Report to Planning and Environment Committee

Subject: 1146-1156 Byron Baseline Road
File SPA21-009
2186121 Ontario Inc. (Birani Homes)

Date: Public Participation Meeting on June 21, 2021

Tree Preservation Plan

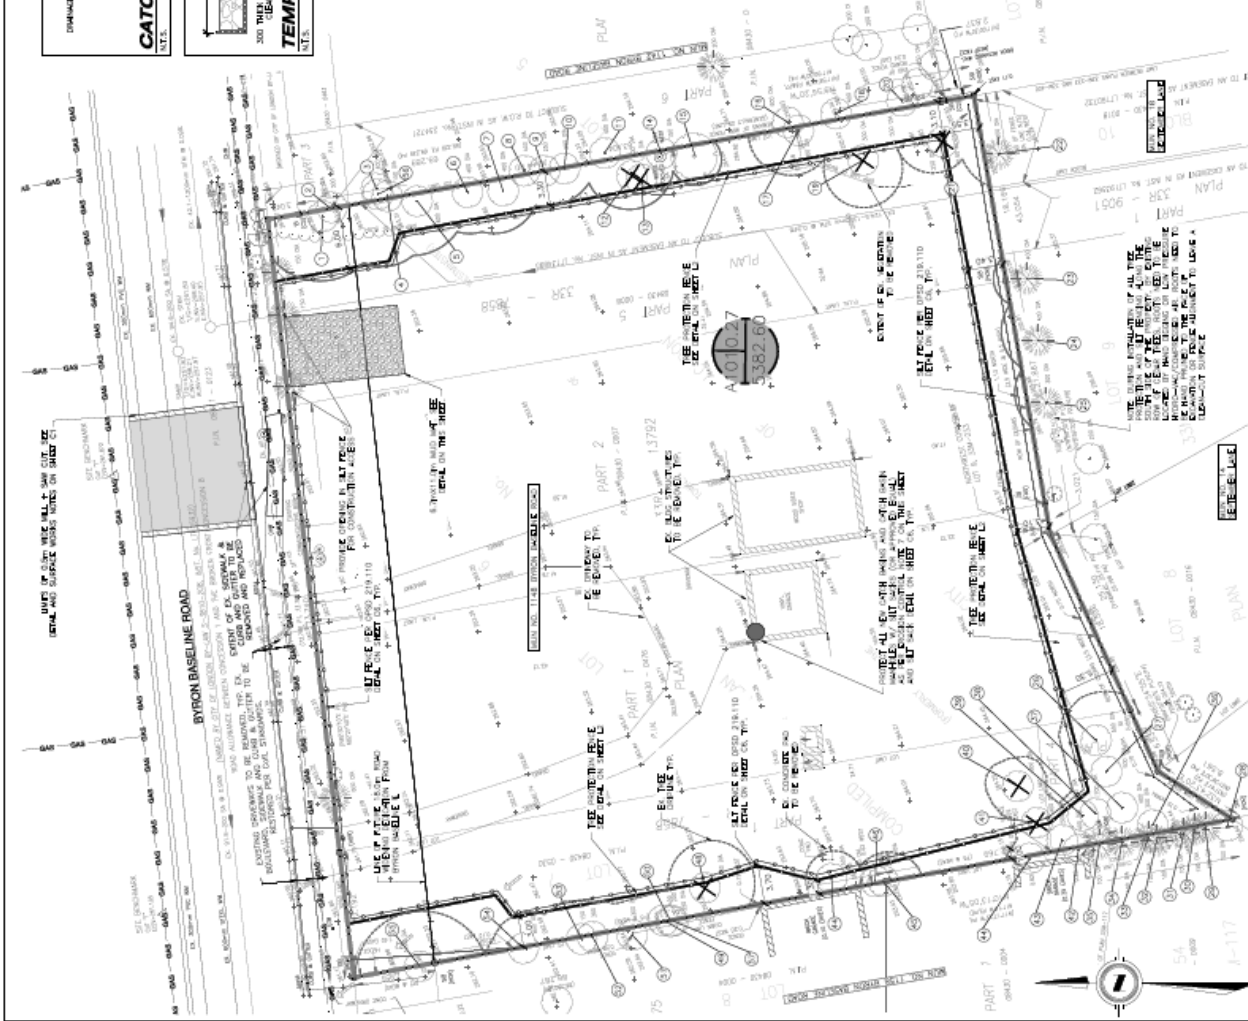
To accommodate the proposed development, seven (7) of the 57 trees on site are being removed to accommodate the proposed development that amounts to 12% of the total trees on site being removed. The seven (7) trees being removed are noted as being in good condition but are required to be removed to facilitate the proposed parking lot and foundation locations. Additionally, there is an existing row of cedars along the southern property boundary that is proposed to be retained, which assist in providing the privacy and screening qualities from the parking lot. Given the amount of vegetation being retained, a tree preservation fence is recommended to be erected along the east, south and west property boundaries.

Landscape Plan

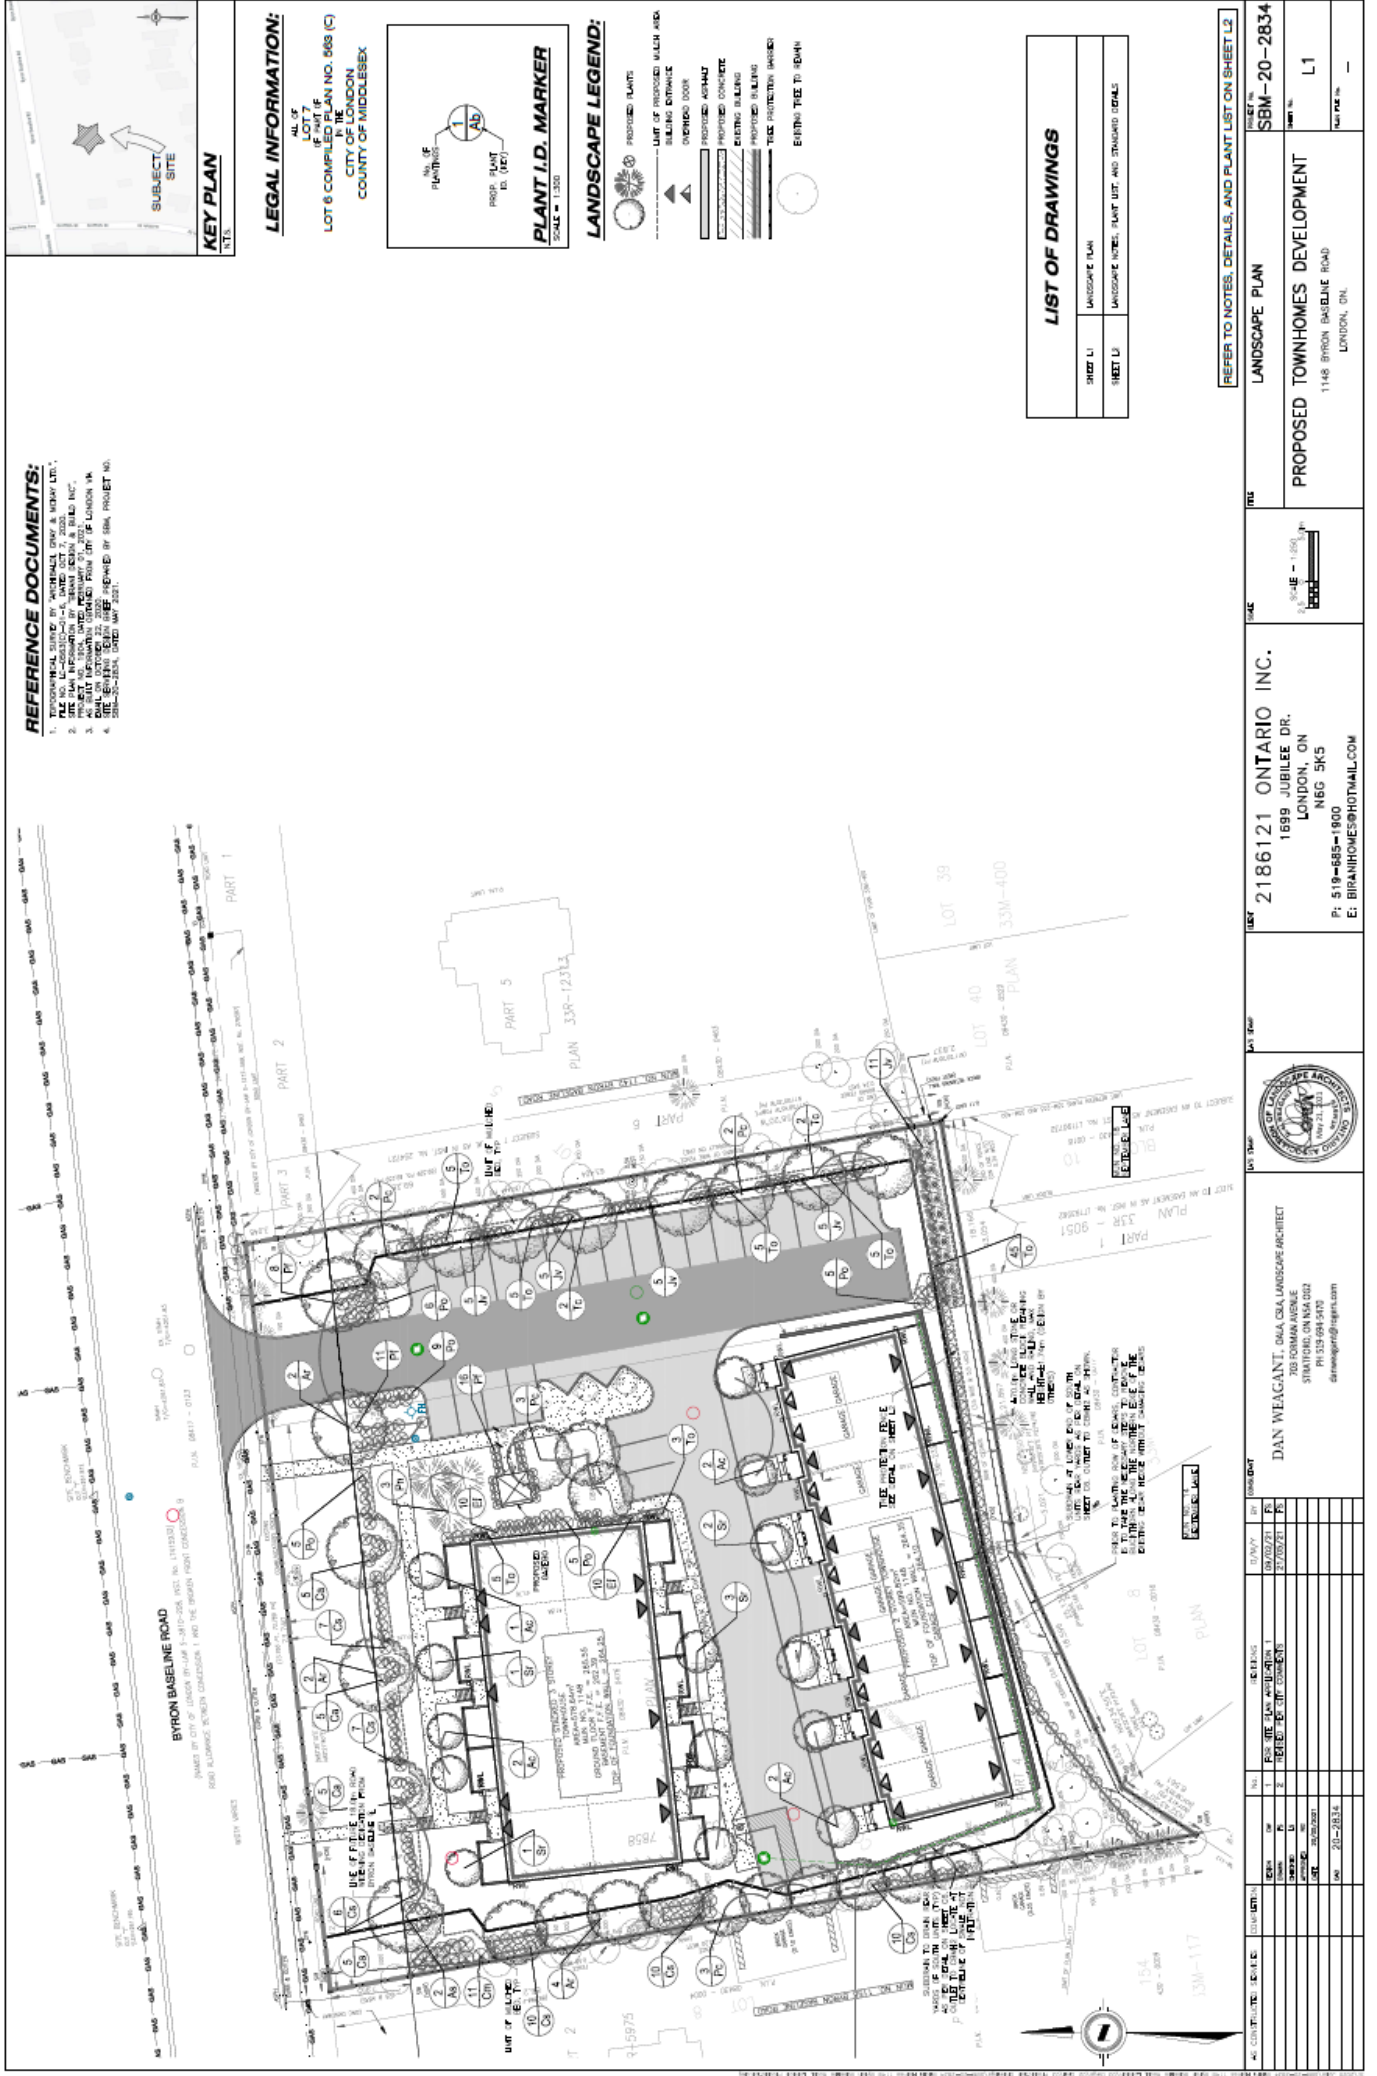
Council requested the enhanced provision of boundary landscaping along the west, east, and south property boundaries that not only exceed the standards of the Site Plan Control By-law but also has screening/privacy qualities. Along with the additional 41 trees proposed to be planted, the applicant is proposing 104 trees to be planted as hedges to provide for the screening qualities. In total, 15 plant species are proposed to be planted for a total of 314 new plantings, including the proposed 41 trees. It being noted that there are a total of 50 trees being retained.

Concerns were raised regarding the health of the existing row of cedars along the southern property line, including the health of the cedars following construction. To provide enhanced screening, additional vegetation is proposed to assist in filling in any gaps that exist along the cedar hedge. Given the health of the existing row of cedars, a clause will be included within the Development Agreement regarding the care of the hedge.

With the number of proposed plantings, ranging from trees to low shrubs and hedges along each property boundary, staff are satisfied the proposed landscaping plan meetings the intent of Council's Resolution.

Also of primary concern is Birani's reliance on the existing cedars trees to provide privacy. The cedar trees do not provide privacy today after years of neglect by Birani. These trees do not and will not in the future provide privacy. An additional cedar hedge row is required to supplement the existing cedar trees.

The boundary landscaping along the East, West and South property boundaries MUST provide for better screening/privacy than what it provides for now. We face south and even with the current vegetation, we have a clear site line to the back of the houses which back on to this land, especially in the winter months. The landscaping MUST provide for privacy/screening for ALL 12 months of the year.

Concerns were also raised about the maintenance of the landscaping, including the health of any existing and proposed vegetation following the development of the site. To address this, a clause will be included within the Development Agreement regarding the monitoring, assessment and replanting of any vegetation on site declining in health.

Photometric Plan

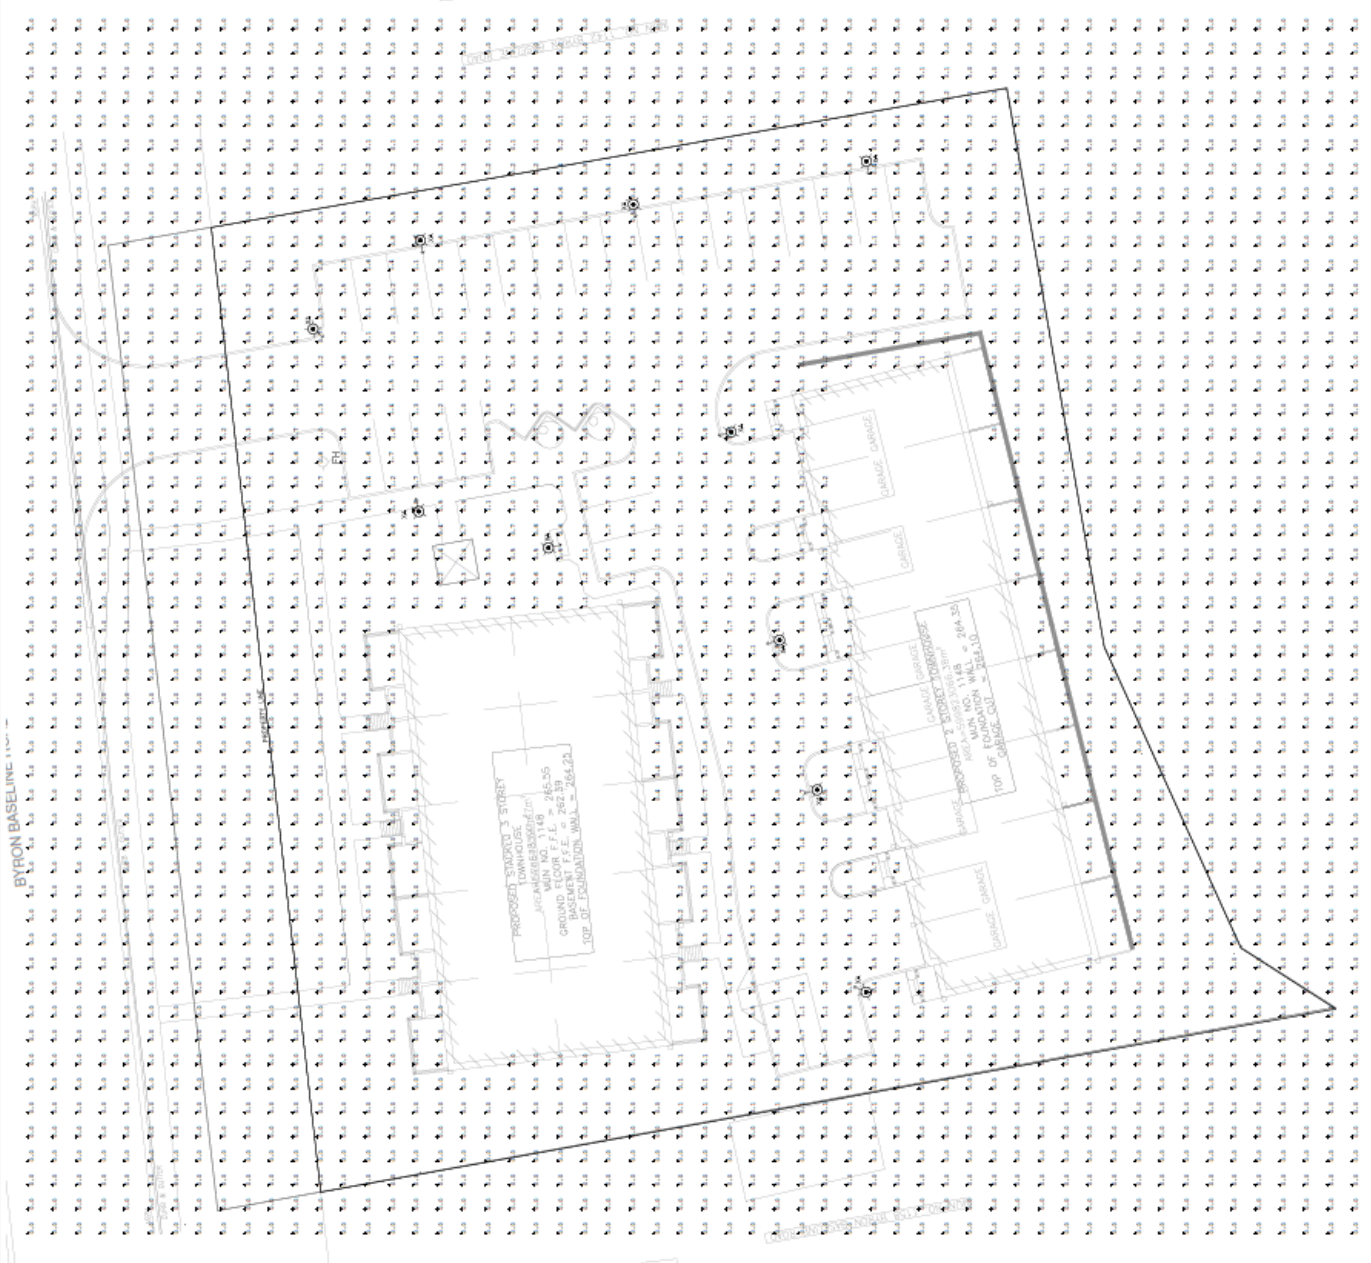
Additional concerns related to the parking area, which includes the impacts light standards on abutting properties as well as the headlights of vehicles. As part of a complete application, a photometric plan was submitted (attached in Appendix "A") where the applicant is proposing a total of 10 light standards. Four (4) of these light standards are proposed to be located in front of the two-storey townhouses with the remaining six (6) throughout the proposed parking lot. Of the six (6) parking lot light standards, four (4) are proposed along the eastern property boundary. Staff are currently reviewing the photometric plan and working with the applicant to ensure there are no lighting impacts on abutting properties due to light flooding.
